## Product Change Notice (PCN)

PCN Number: **PCN-0451399R-01**

Product(s) Affected: *PJ-063AH & PJ-063BH*

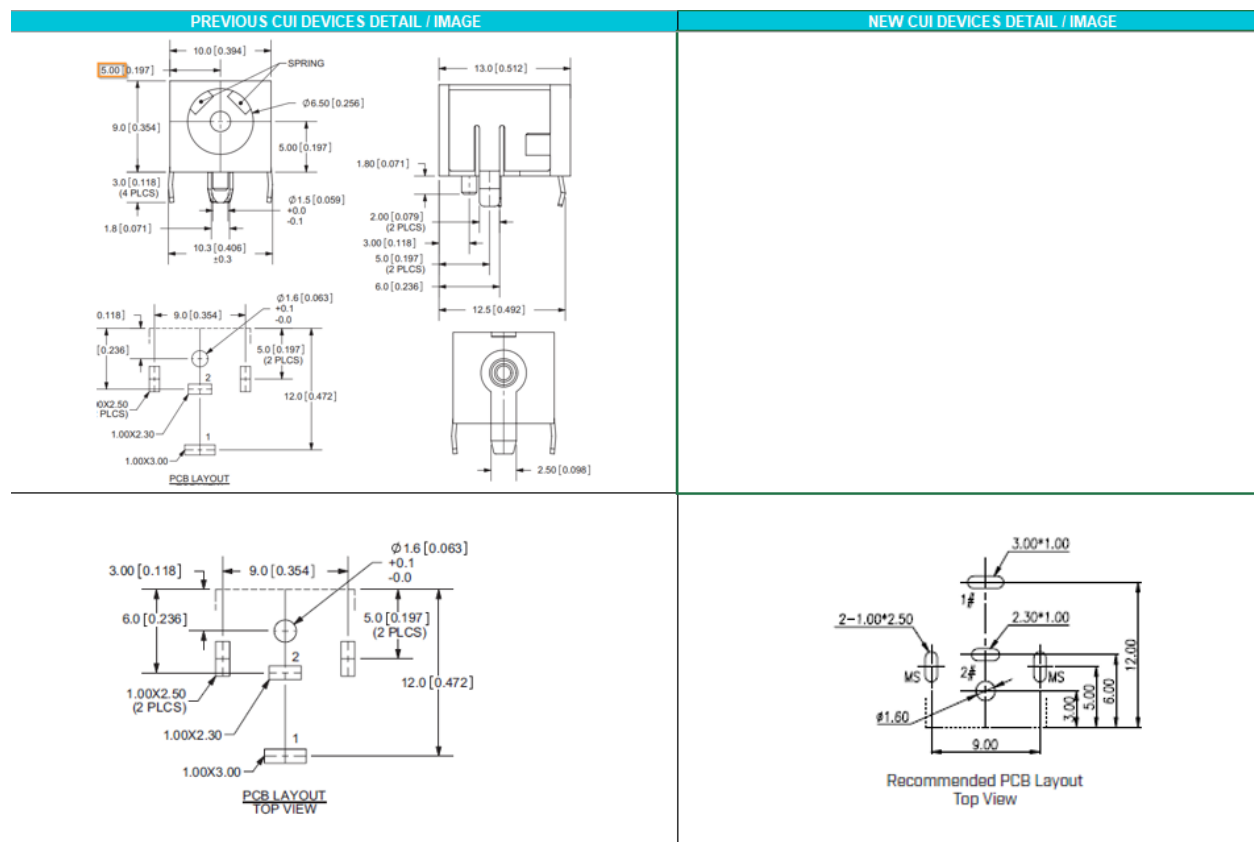
Description of Change: *Mold Change. Cosmetic differences on the mold. Stamping removed ("P" & "Made in China") All measured dimensions on the 2D drawing remain the same.*

MATING PLUG  
Jack Insertion Depth: 8.85 mm

MATING PLUG  
Jack Insertion Depth: 8.30 mm
